FLR allocation for 800GBASE-ER1/ER1-20  
(comment #585 against 2.0)

Gary Nicholl – Cisco

IEEE 802.3dj, 16 July 2025

# FLR allocation for 800GBASE-ER1/ER1-20 (option #2 of brown\_3dj\_04a\_2503)

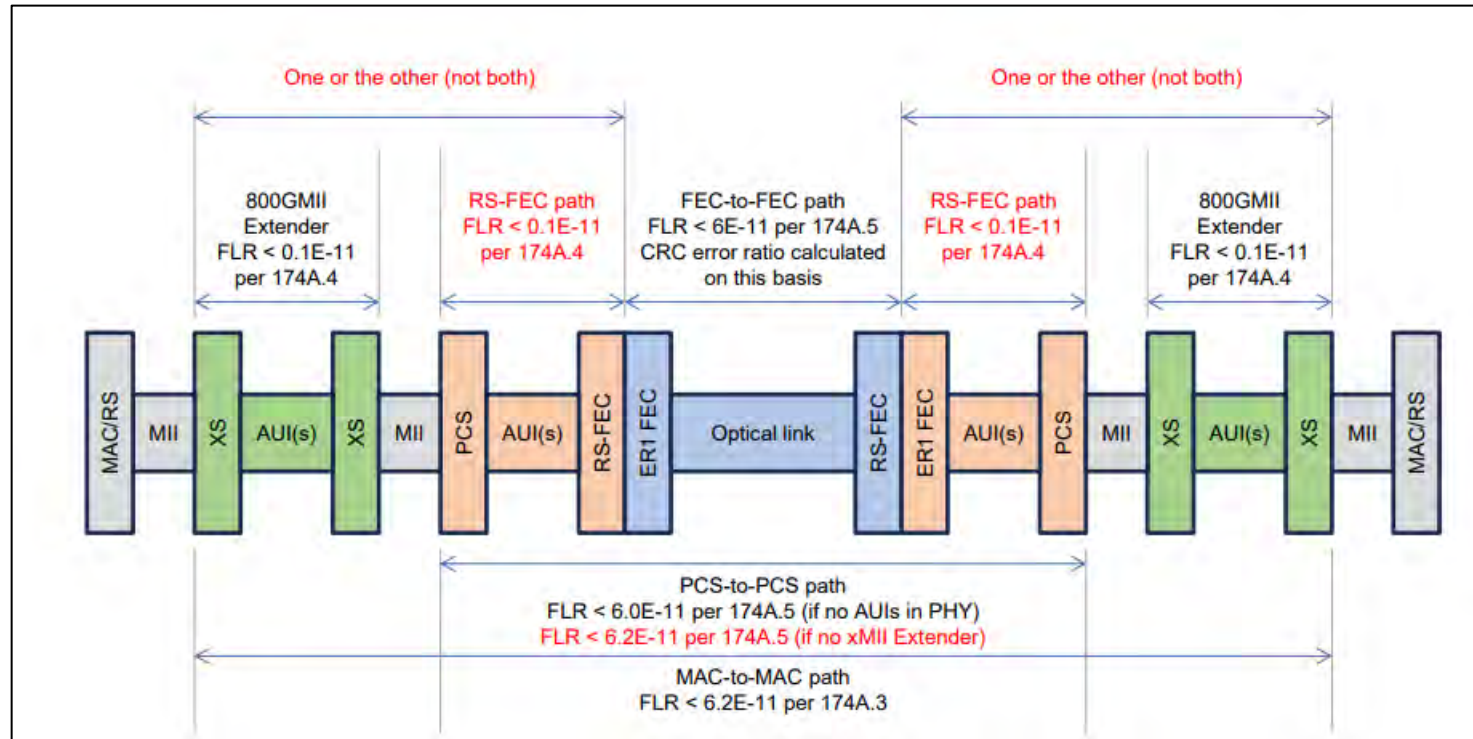
- FLR allocation only supports AUIs in either xMII Extender or PHY
- FLR allocation for PHY-to-PHY is different in the two cases

If an ER1/ER-20 module (with C2M AUI in the PHY) is plugged into a host with an 800GMII extender, FLR budget is broken

# FLR allocation for 800GBASE-ER1/ER1-20 (option #3 of brown\_3dj\_04a\_2503)

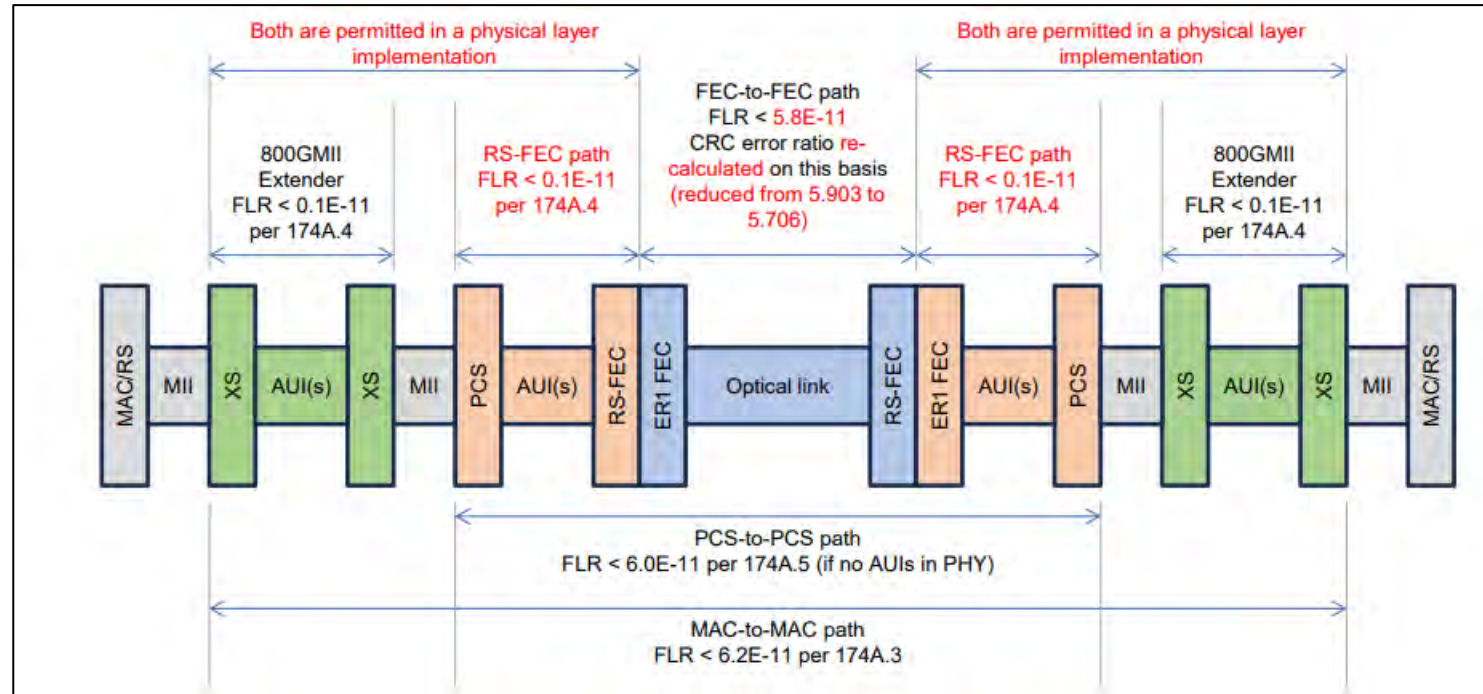
- Consistent with all other 802.3dj PHYs
- Single FLR allocation for PHY-to-PHY of < 6E-11
- Need to reduce ER-1 FEC-to-FEC FLR from 6E-11 to 5.8 E-11 (minor)

Ensures that all 800GBASE-ER1/ER1-20 solutions are plug-and-play with all potential hosts

# Proposal

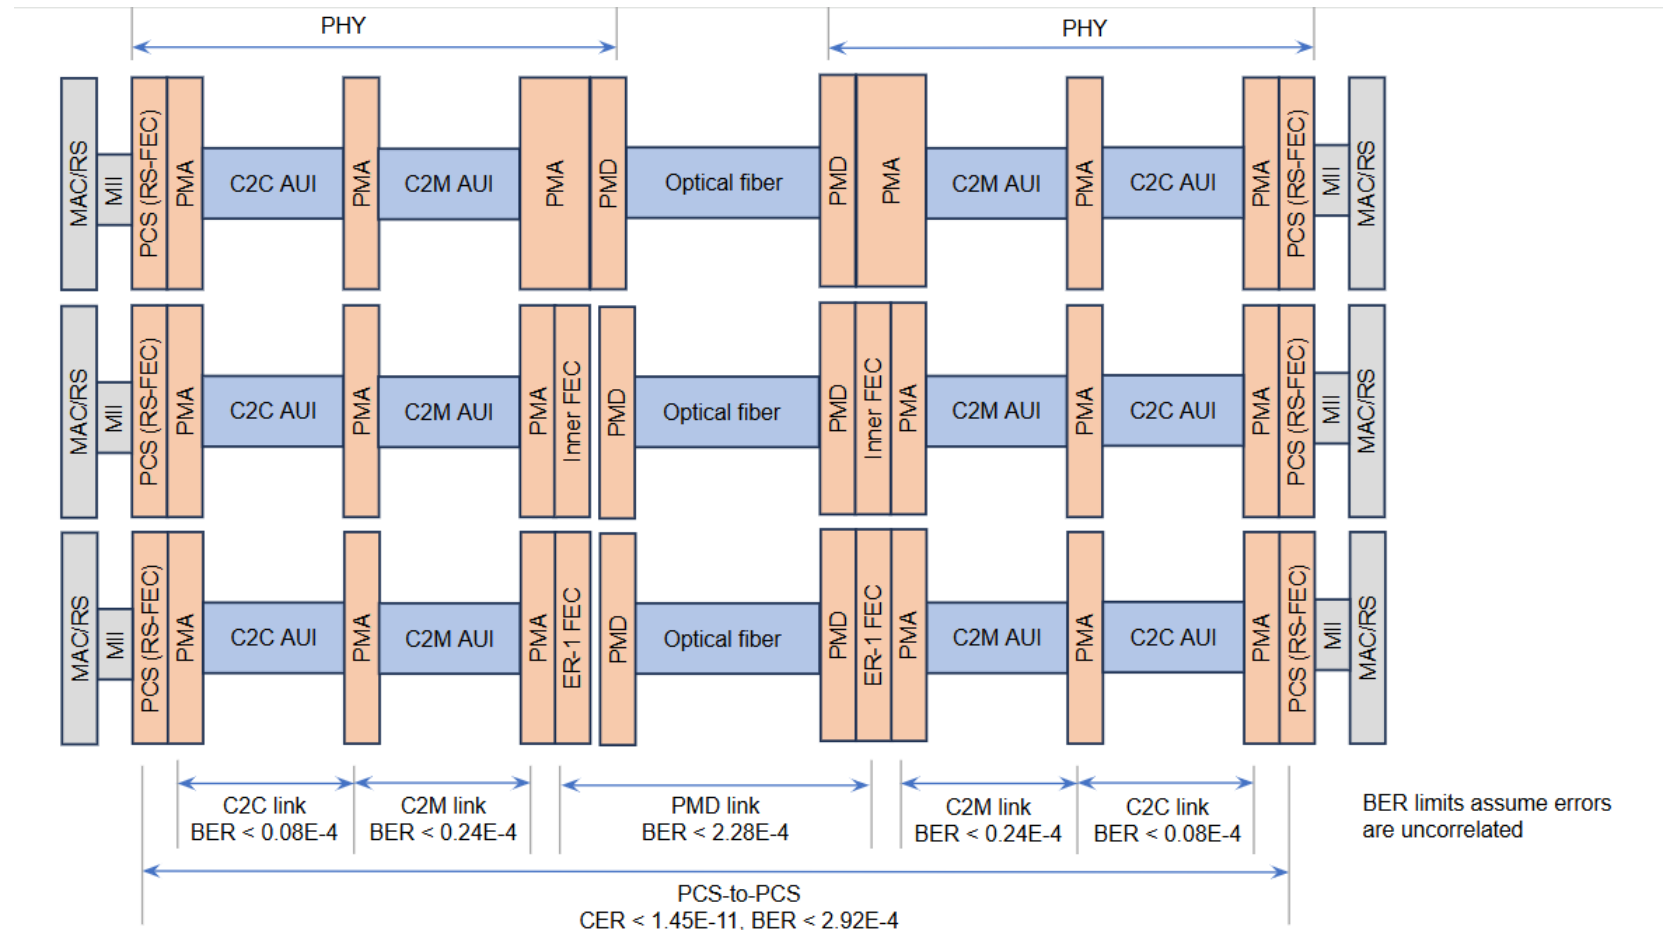
- Update the draft to implement option #3 of [https://www.ieee802.org/3/dj/public/25\\_03/brown\\_3dj\\_04a\\_2503.pdf](https://www.ieee802.org/3/dj/public/25_03/brown_3dj_04a_2503.pdf)
